CNL-14-142

**Subject: WATTS BAR NUCLEAR PLANT (WBN) UNIT 2 – RESPONSE TO
REQUEST FOR ADDITIONAL INFORMATION RELATED TO RELIEF
REQUESTS ASSOCIATED WITH UNIT 2 INSERVICE TESTING (IST) AND
PRESERVICE TEST PROGRAMS (MF4118)**

**Responses to Request for Additional Information Related to Relief Requests Associated
with Unit 2 Inservice Testing (IST) and Preservice Test Programs (MF4118)**

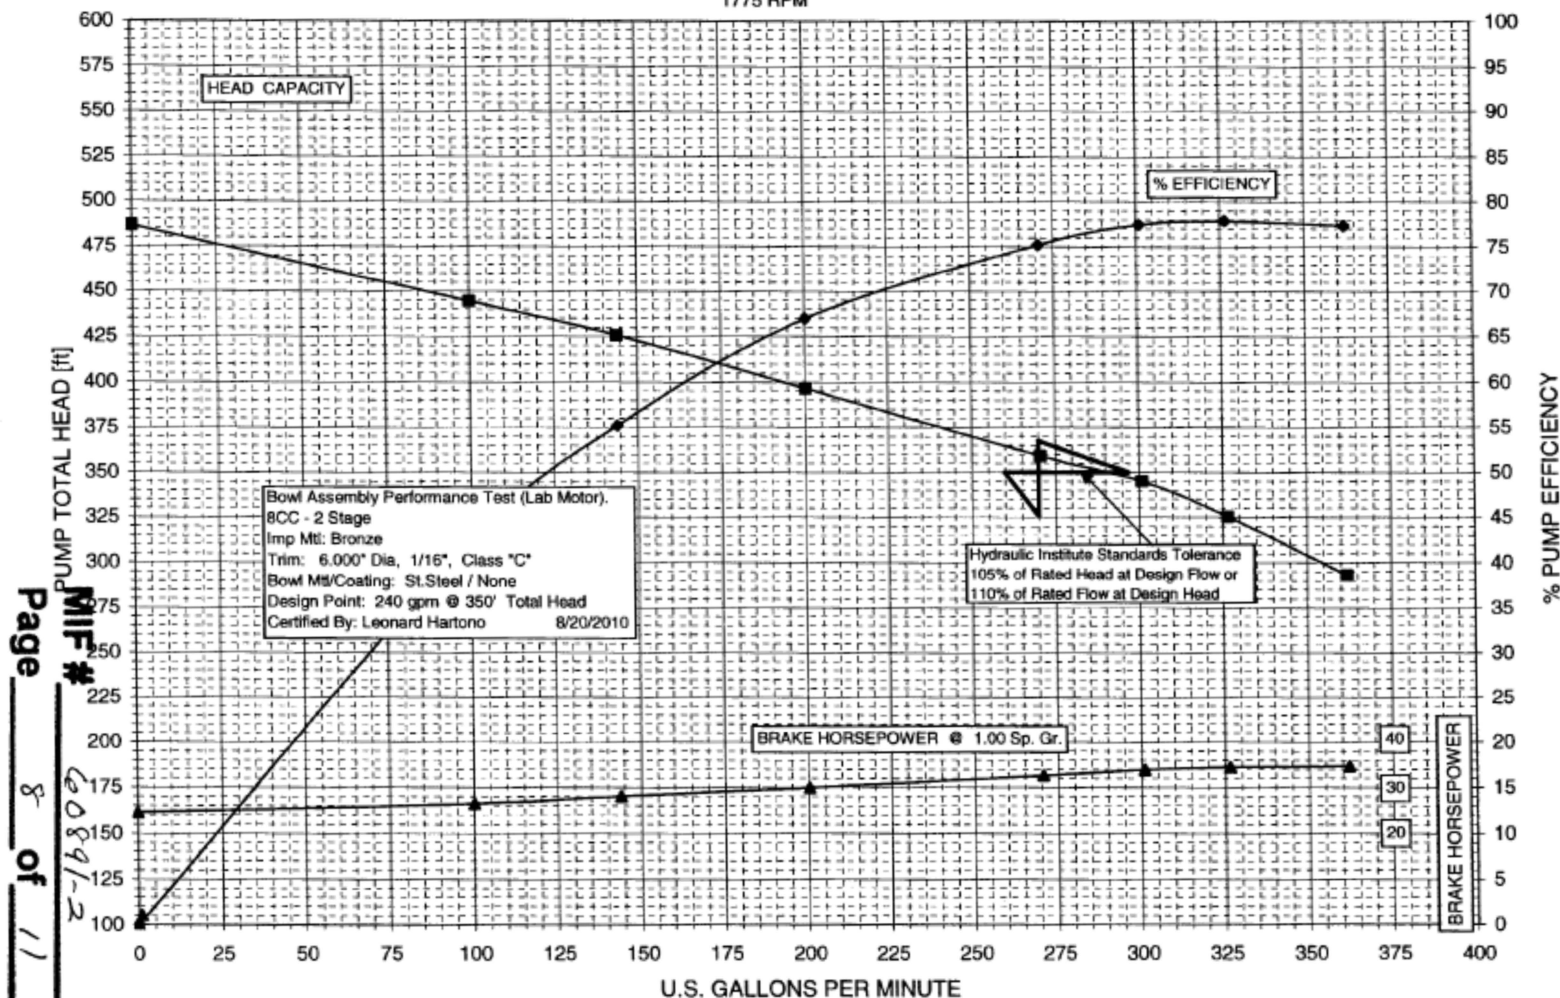
For Valve Relief Request IST-RR-4, you propose to perform set-pressure testing of the pressurizer safety valves at an approved vendor test facility within 6 months prior to initial reactor criticality. Please provide details about the test environment such as temperature and humidity and describe the test configuration such as orientation of the valves during testing. Also discuss what will be done to assure that the set-pressure will not be altered during shipment and installation.

The pressurizer safety valves will be set pressure tested using steam at the same facility that tests similar or identical valves from TVA and many other nuclear utilities in accordance with the requirements of ASME OM code Appendix I. The valves will be installed on a steam test header at the vendor test facility in their normal vertical operating position. The valves will be thermally stabilized in an environmental chamber to an ambient temperature of 135°F ±5°F for a minimum of 12 hours prior to test. As part of thermal stabilization, the steam accumulator and the valve inlet will be pressurized with saturated steam at 90% of the valve set pressure for a minimum of 6 hours. After thermal stabilization is completed, testing for pre-test seat leakage, as-found or as-left set pressure, and post-test seat leakage will be conducted using saturated steam in the environmental chamber. A final seat leakage test using gaseous nitrogen will be conducted outside the chamber at ambient conditions prior to releasing the valve for return to WBN.

Humidity is not measured during the testing because it is not a code requirement and is not a critical parameter.

The valves are shipped to the vendor test facility and returned in an upright position. They are inspected upon arrival at the vendor test facility and on return to WBN for damage or alteration. The valves are stored in a controlled storage area at the vendor test facility or at WBN during any prolonged non-testing period. Prior to and after testing is completed, the adjusting bolt locking device will be verified and/or torqued to 150 ft-lbs. Lockwires and seals will be installed to prevent changes to the certified valve set pressure. Valves will be lifted using approved lifting points and Foreign Material Exclusion (FME) will be maintained while the valves are removed from the system. The requested alternative is an activity normally performed during refueling outages for U1. The same site organizations and procedures/practices used for handling and shipping the U1 valves will be used to perform this activity. No instances have occurred in U1 where handling, shipping, storage, or removal/installation issues have resulted in changes in set pressure of these valves.

Brookshire, Texas
Customer: Chattanooga Svc. Center
Job# 100055823, TC-15064, Rev # 0
PO: 4500205719-0, S/N: 436945, Fluid: Water
1775 RPM

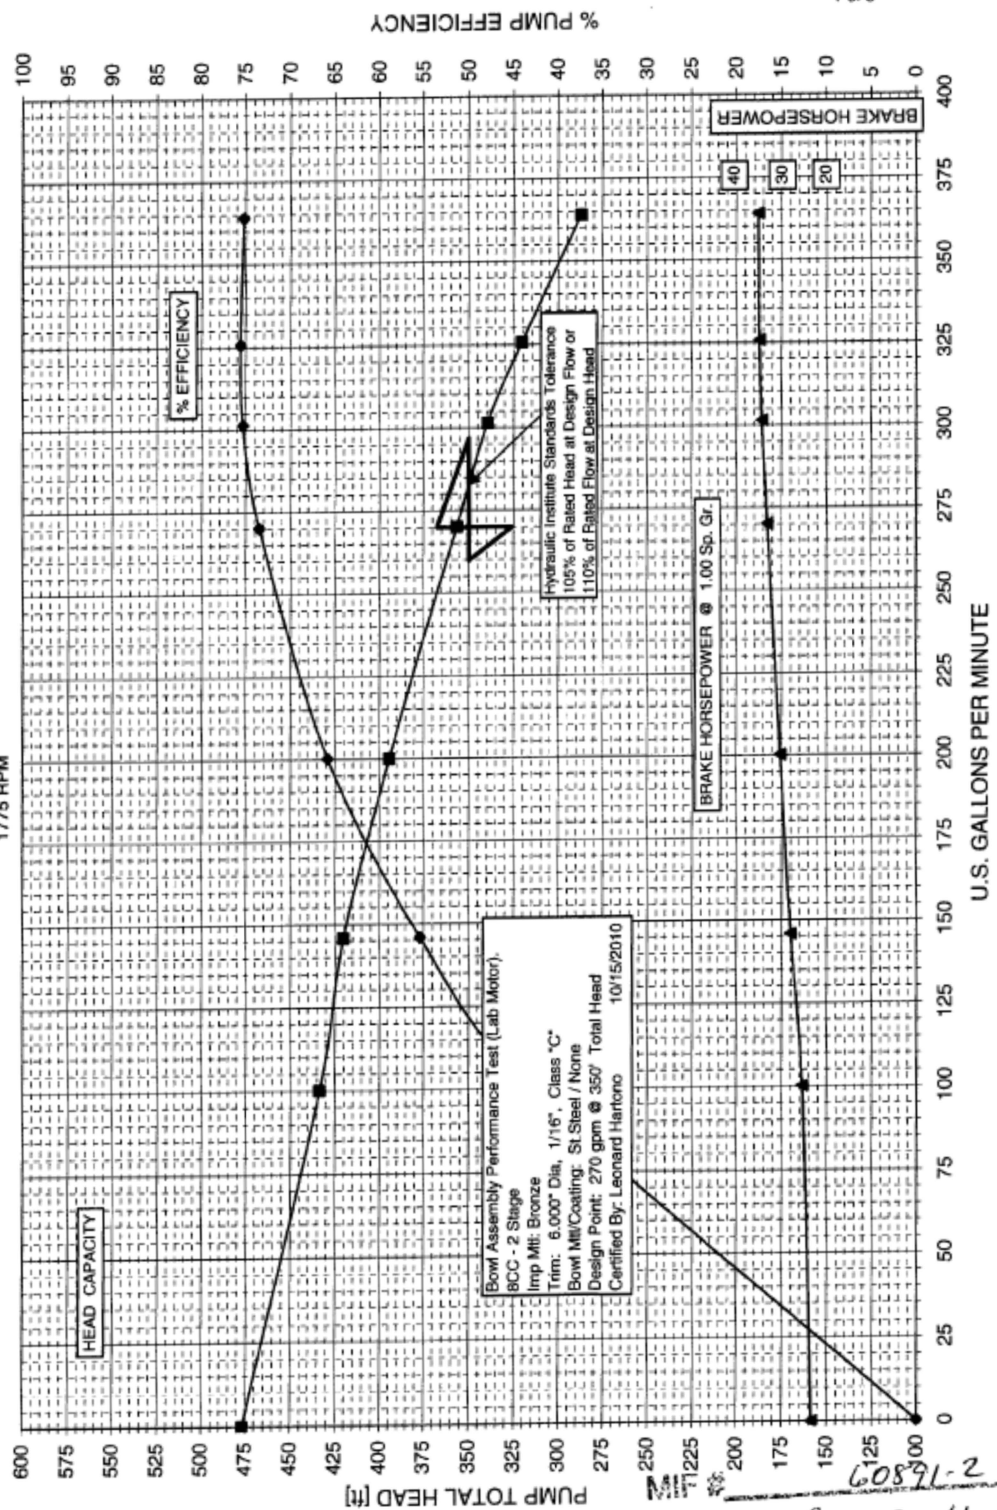
“For Pump Relief Request IST-RR-2, you state that preservice test data for differential pressure and vibration data will be evaluated to verify that it represents acceptable pump operation. Please explain how this will be done. Also, provide the manufacturer’s pump curve for the ERCW Screen Wash Pump (pump ID 1-PMP-67).”

The U1 1A pump has been replaced by a replacement model (S/N 434485) from Sulzer. The U1 1B pump is scheduled to be replaced in the near future, also with a replacement Sulzer model (S/N 436945). The U2 2A and 2B pumps are the original Johnston models (S/N NJ-1762 and NJ-1764, respectively). Available pump curves for the original and replacement pumps are attached.
